Expert Report of Greg Karras

Communities for a Better Environment (CBE)

Phillips 66 Company Propane Recovery Project

Draft Environmental Impact Report released in June 2013 by the
Contra Costa County Department of Conservation and Development
State Clearinghouse #2012072046
County File #LP12-2073

Chart 1. Crude oil supply sources to California refineries, 1982–2012

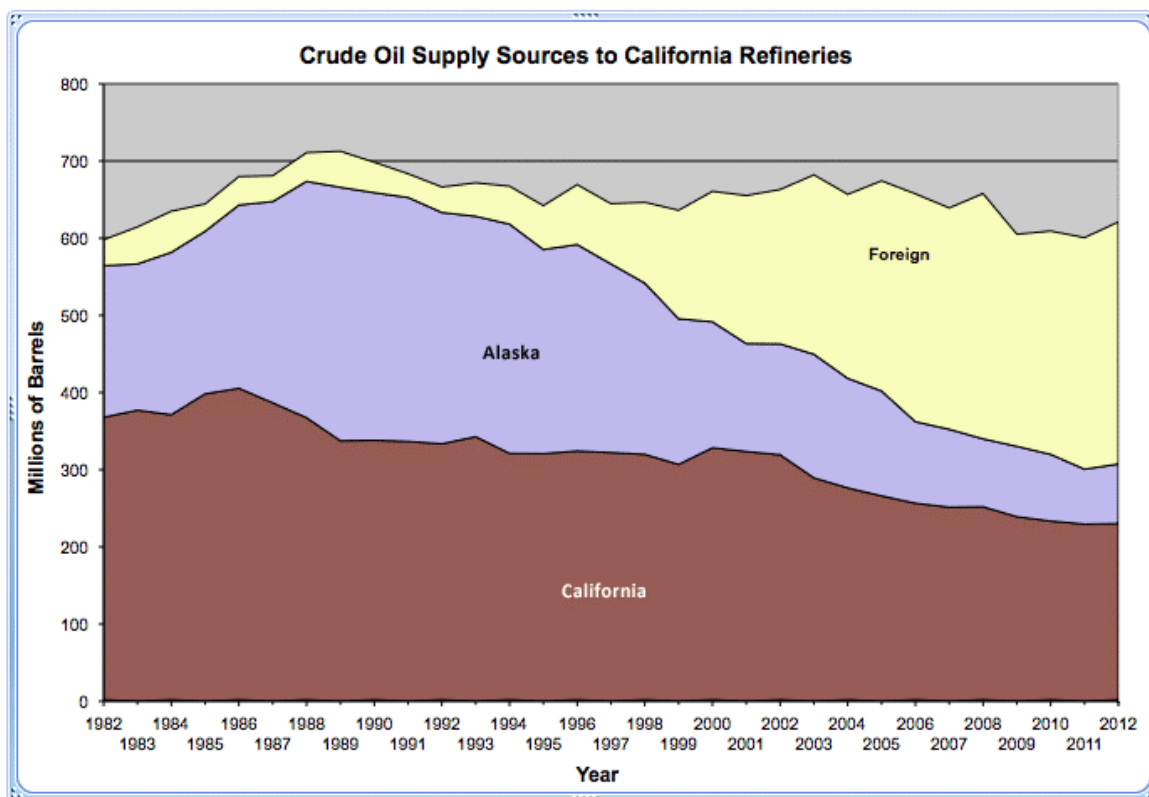
12. Impacts of the project that would emerge later and are obscured by this omission include those from its effects on a concurrent feedstock switch. California refiners’ long-stable and dominant sources of crude oil are dwindling, driving an historic refinery crude switch. See Chart 1. Foreign crude was only 6% of total California refinery crude feed in 1990; in 2012 it was 51%.¹⁰ By 2020, roughly three-quarters of the crude refined statewide likely will *not* be from currently producing sources in California or Alaska.¹¹ Because it relies on dwindling California oil supplies via pipeline for most of its crude feed,¹² the SFR almost certainly will be among those California refineries that switch crudes dramatically during the project’s operating life. Indeed, the refinery’s 1995 wharf project forecast this outcome,⁹ and its recent related project to allow 67% more crude delivered via its wharf¹³ would begin to implement the switch. Among other problems, omitting the operating life of the project obscures the project’s implications for the choice of new crudes, and the impacts of that feedstock choice.

Chart 2. Sulfur and imports content of West Coast refinery crude feeds, 1985–2012
PADD 5 data from the U.S. Energy Information Administration (www.eia.gov/petroleum/data.cfm).

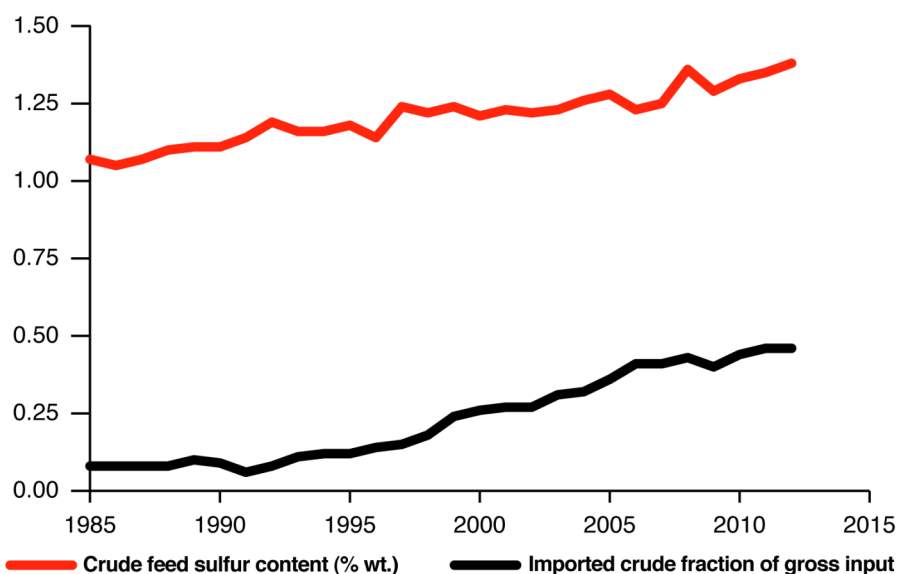
19. This new, dense crude slate likely will include more oil derived from “tar sands” bitumen. The project would commit the refinery to coker feed-rich crude over a period when the worldwide portion of high-density crude supplied by “heavy oil” and bitumen is likely to grow dramatically.²⁸ Bitumen has already come to dominate crude production in Canada,²⁹ the largest source of U.S. crude imports.³⁰ Moreover, crude can account for up to 90% of a refinery’s operating costs,³¹ and tar sands bitumen is price-discounted (due in part to delivery constraints),³² so Phillips 66 is incented to run it, especially since the company’s affiliates produce two of the bitumen blends shown in Table 3.³³ Indeed, recent major projects expanded the Rodeo facility’s capacity to run more of these oils.³⁴ It now has vacuum distillation capacity to process a crude slate with atmospheric residua yield as high as 73% of the barrel, and coking capacity to process a slate with vacuum residua yield as high as 39% of the barrel,³⁵ which is more than enough to run the bitumen blends shown in Table 3.

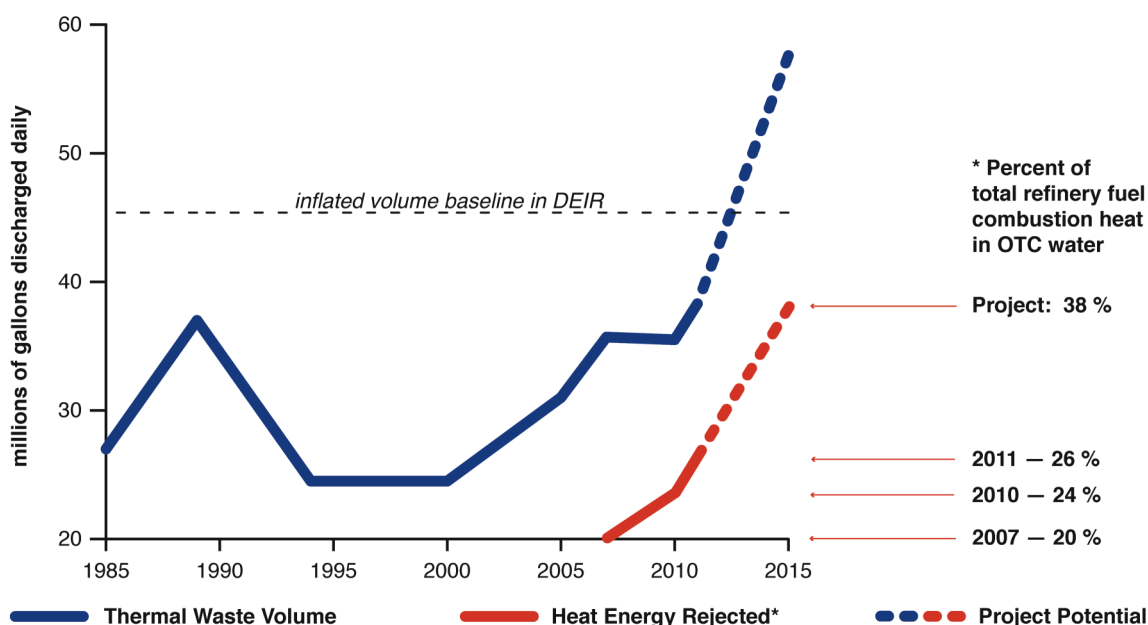
29. Total heat rejected by OTC would grow, from ≈ 6.3 – 6.8 million gigajoules/year during 2007–2011 to ≈ 10.2 MM GJ/yr as a result of the project.⁴⁷ Waste heat rejected by the project flow increment (≈ 3.4 – 3.9 MM GJ/yr) would greatly exceed the total energy of additional fuel the DEIR states the refinery could burn for the project (1.23 MM GJ/yr).⁴⁸ Consequently, refinery wide reliance on OTC to reject waste heat would grow, from ≈ 20 – 26% of all fuel energy burned in the facility during 2007–2011, to $\approx 38\%$ of post-project refinery energy use.⁴⁹ See Chart 3. The DEIR does not identify or explain the discrepancy between the fuel it says the project would burn and the heat its expanded OTC could carry, and it does not disclose this increased refinery wide reliance on OTC.

30. This increased reliance on OTC to carry heat from as-yet unidentified sources is consistent with an undisclosed increase in firing rates to process denser, higher sulfur crude feeds—which are known to increase refinery energy intensity.⁵⁰ It is consistent, also, with a shift from existing cooling towers to OTC—which might yield savings on cooling tower makeup water and chemicals.⁵¹ Confirming or quantifying either or both possibilities may require cooling system design information that the DEIR does not provide. Regardless of its specific uses in cooling the refinery, however, the project’s expansion of OTC would conflict with ongoing efforts to phase out and replace OTC.

Chart 5. Richmond refinery feedstock quality / 4-Sidecut pipe corrosion, 1989–2012.
From testimony presented in the 19 April 2-13 U.S. Chemical Safety Board public hearing at Richmond, CA.

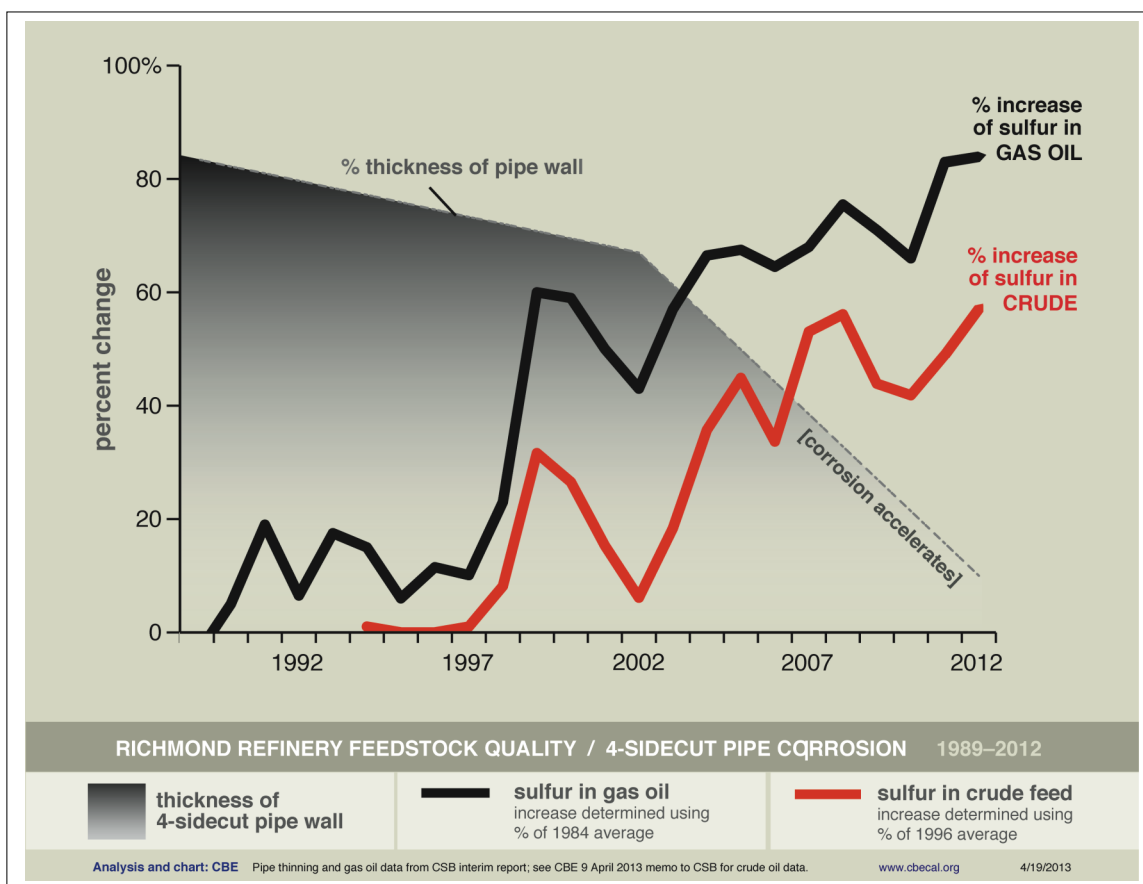
59. Switching to higher sulfur crude was a causal factor in the disastrous Richmond refinery fire on 6 August 2012. See Chart 4. Sulfur corrosion of the pipe section that ruptured catastrophically in the incident (gray shading), sulfur in the gas oil running through this pipe (black line), and sulfur in the refinery crude feed supplying that gas oil (red line) are shown in this chart. The percent change from baselines is shown.¹⁰¹ As sulfur increased in the crude, it increased in the gas oil distilled from that crude and running through the pipe, and sulfidic corrosion began to thin the wall of this pipe more than four times faster than before that dramatic sulfur increase. See Chart 4. This example of an ultimately disastrous feedstock substitution hazard applies to the SFR and the even more inherently hazardous crude feed that likely would result from the project.

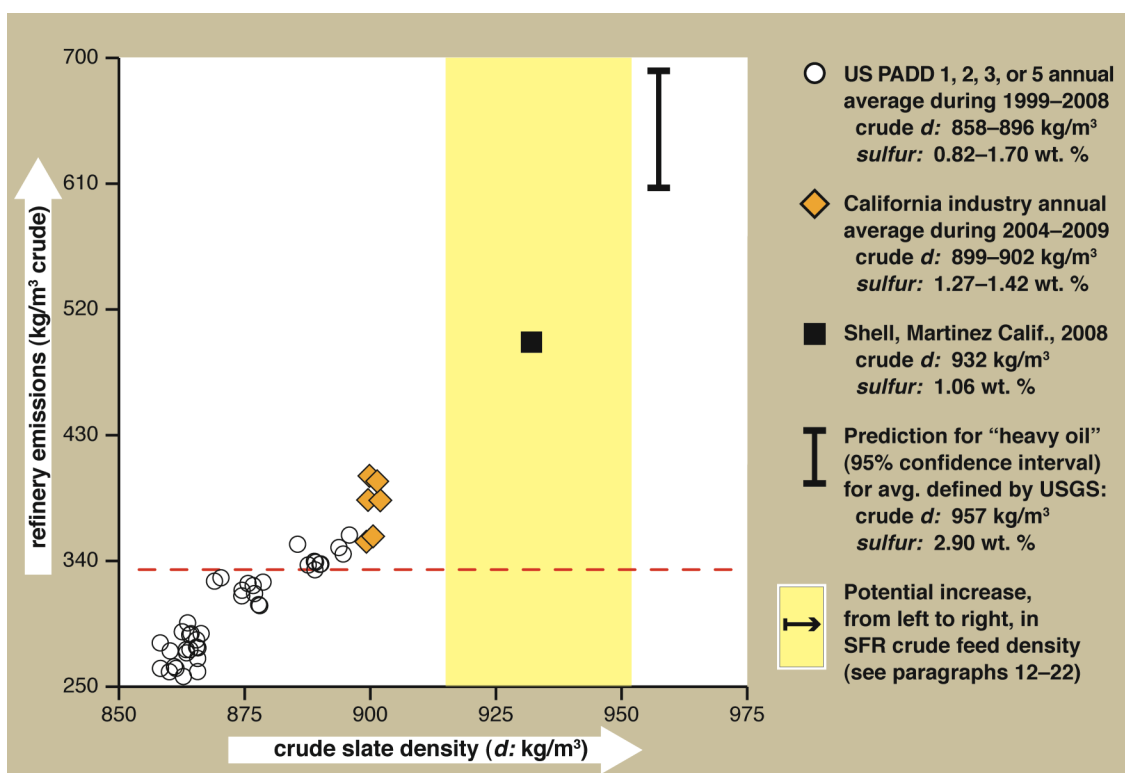
slate density from 915–952 kg/m³ and sulfur from 1.5–3.4% could increase the average refinery’s energy intensity by ≈2.75 GJ/m³ crude refined.¹¹⁷ Assuming the refinery fuels reported in the DEIR,¹¹⁸ and this average energy increment, SFR emissions of CO₂ would increase by ≈135 kg/m³, or ≈940,000 tonnes/year. (Each 90 kg/m³ increment on the vertical scale in Chart 5 represents emission of 627,000 tonnes/yr at SFR’s 120,000 b/d capacity.) This ≈940,000 tonnes/yr value indicates the scale of potential impact rather than its precise quantification, as discussed directly below.
